A G E N D A JAMES CITY COUNTY DEVELOPMENT REVIEW COMMITTEE REGULAR MEETING

Building A Large Conference Room 101 Mounts Bay Road, Williamsburg, VA 23185 July 27, 2016 4:00 PM

SUBJECT: The Promenade at John Tyler: Appeal of a decision of the Director of Planning

SITE PLAN-0052-2016. Williamsburg Memorial Park Ossuary

GENERAL NOTES:

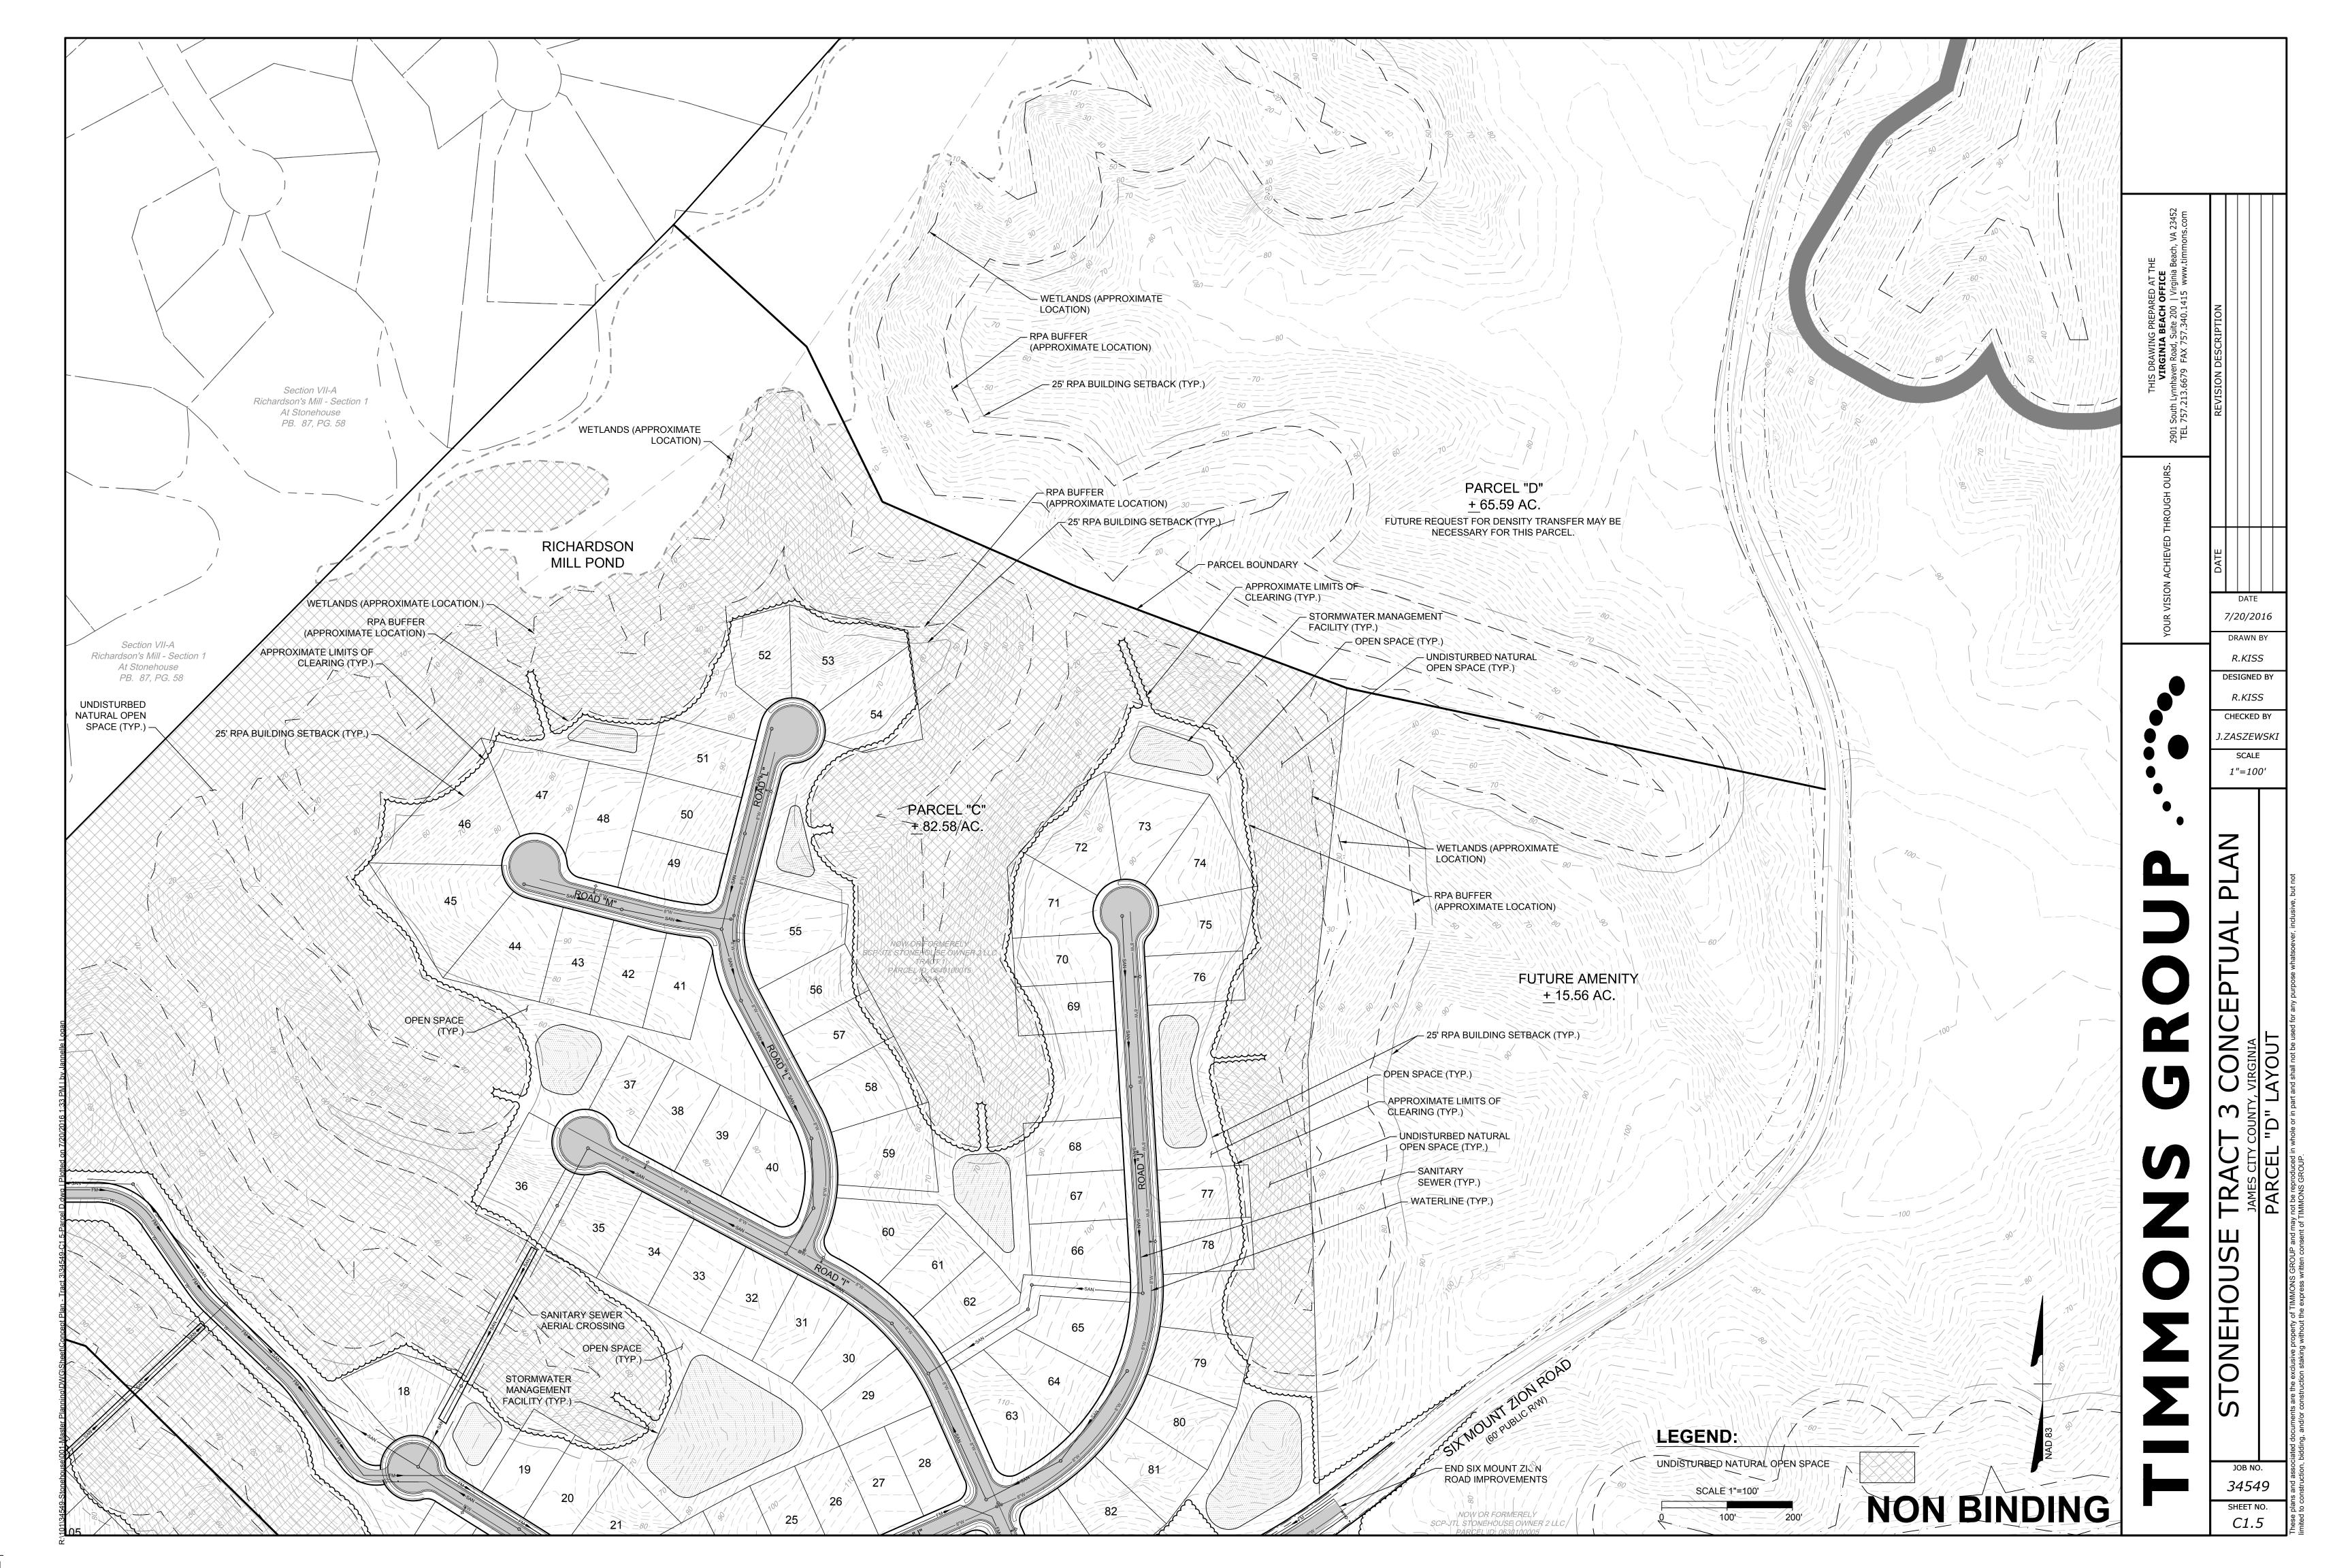
- be references to approved rezoning case Z-06-12 and Z-04-07 which have additional proffers applicable to this land bay.
- 4. Labels. On the conceptual plan cover sheet, provide a label to indicate Richardson Mill Pond with County BMP ID Code WC059. On conceptual plan drawing Sheets C1.1 and C1.2, label the Laurel Park Grove Clubhouse (ie. Amenity Center H) with text to identify approved County Plan No. SP-08-09. On Sheets C1.1 through C1.4 include text to indicate VDOT State Route number, as applicable, for Six Mount Zion/Holly Forks Road (ie. SR600, etc.).

- 19. BMPs. On detailed conceptual development plan Sheets C1.2 through C1.4 label the type of stormwater management/BMP facilities as proposed consistent with County BMP manual designations (ie. wet extended detention, dry detention, timber walls, dry swale, bioretention, etc.).
